STAFF RECOMMENDATION

NCPC File No. 6479

**PATENT OFFICE BUILDING
SOUTH STAIR RECONSTRUCTION
G, F, 7th and 9th Streets, NW
Washington, DC**

Submitted by the Smithsonian Institution

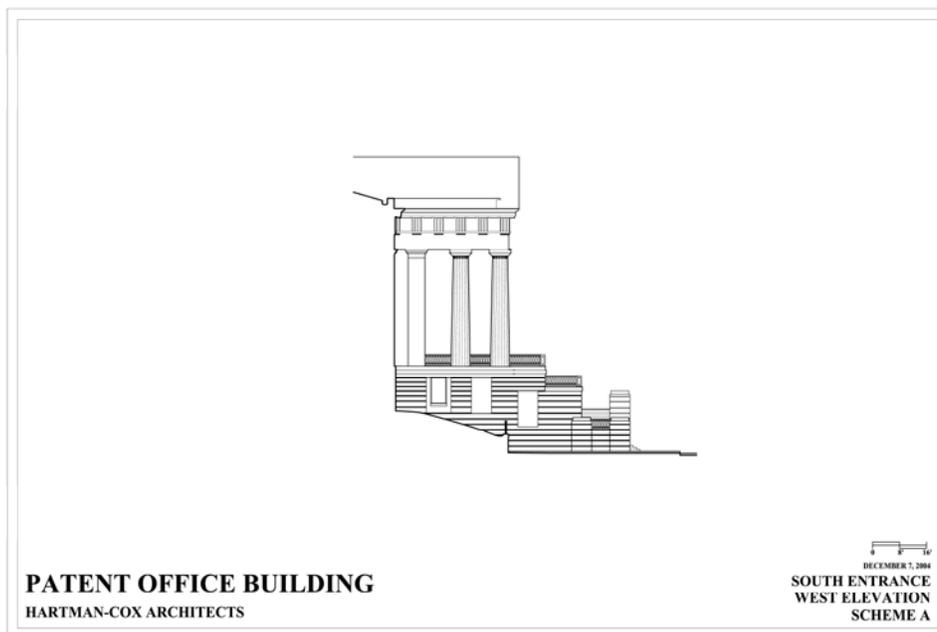
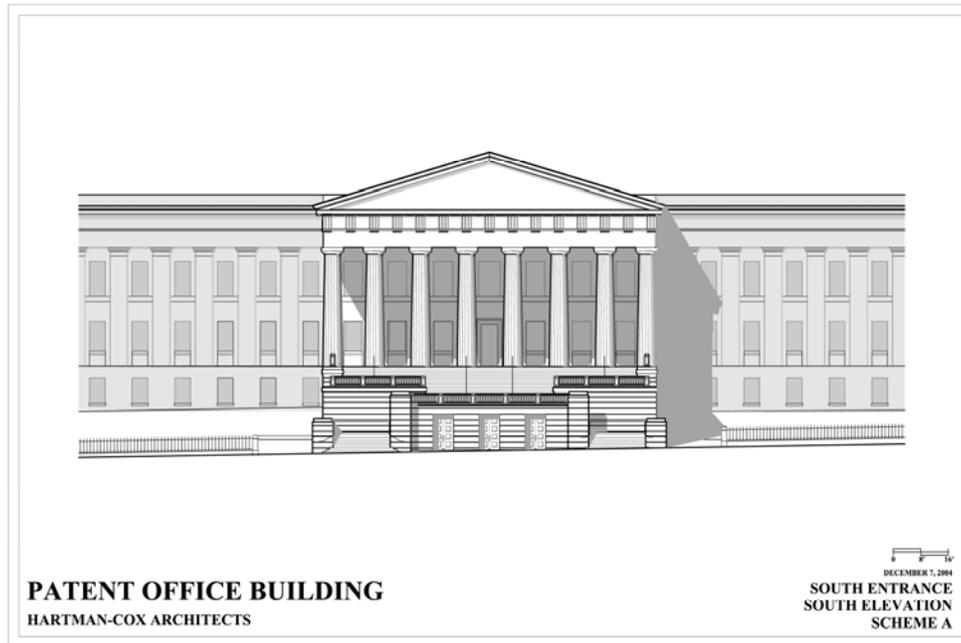
The staff commends SI and its design team for proposing an elegant staircase that reflects the appearance and function of the historic stair while responding to modern requirements for access and museum program. The staff recommends **approval of the concept design** for the south stair reconstruction.

The retention of entrance doors at the sidewalk level while reconstructing a staircase that rises full height to the portico level is a significant design achievement. Thus, while preserving the Smithsonian's interior museum program, the desire for access from the sidewalk, and the importance of interior and adjacent handicapped accessibility, the proposed stair design also admirably fulfills the requirement for a stair reconstruction that returns the south façade of the Patent Office to an approximation of its historical appearance. Only through a reconstructed stair rising to the portico level can SI fulfill its requirement to mitigate the adverse effect and visual impact of the courtyard enclosure and canopy. The current proposal will achieve the architectural and functional requirements of a monumental staircase on the Greek Revival-style Patent Office and underscore and enhance its presence in the L'Enfant Plan reservation and right-of-way vistas.

Staff anticipates that the new staircase, which can serve as a public viewing and seating platform, will make a very significant contribution to the public life of F Street and Downtown. It will become a unique civic feature unavailable and unattainable elsewhere in Downtown, as a public meeting place, and as a raised belvedere providing some of the best views in Washington.

Although the Smithsonian, directed by the Commission in its November 2004 action, has focused on the staircase itself in this design concept, staff recommends that the Smithsonian study and improve the immediate setting of the staircase on F Street during the next phase of design development. The building renovation currently underway does not include any funds for the removal of the former Streets-for-People plaza pavement. SI should proceed with y with appropriate sidewalk materials and design in front of its building, installing pavement and planting properly aligned street trees.
